K.C Jacket Wear Company

30th June 2019

Observations

Observation : Building-1 (KC jacket building)

Apparently non-engineered fire escape stair of utility building.

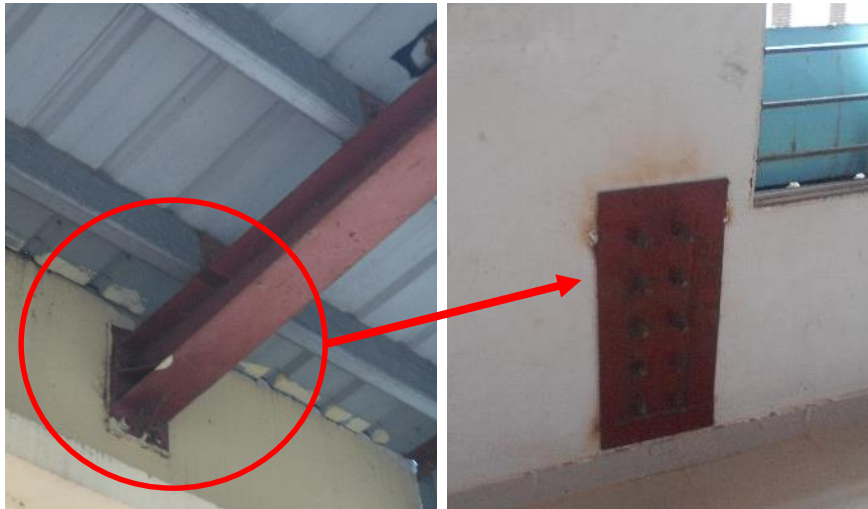
Apparently non- engineering stair. Building engineer is required to check the adequacy of the stair.

Poor connection details

Poor connection details

Connection of the canopy

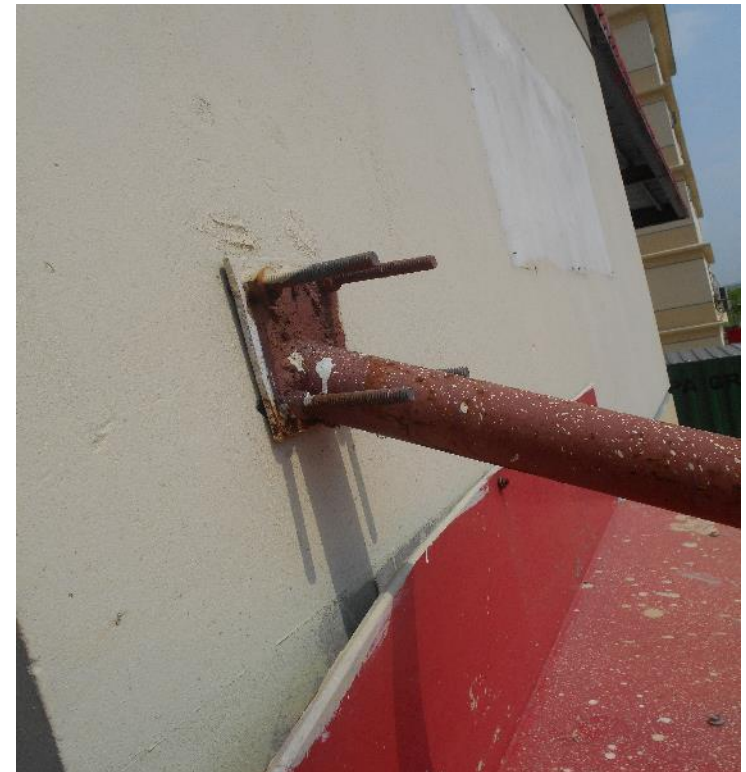
Canopy structure

Rafter connected with brick façade.

Connection between tension member and the brick façade wall.

Apparently inadequate connection of the canopy structure. Building engineer is required to check the connection for the uplift force.
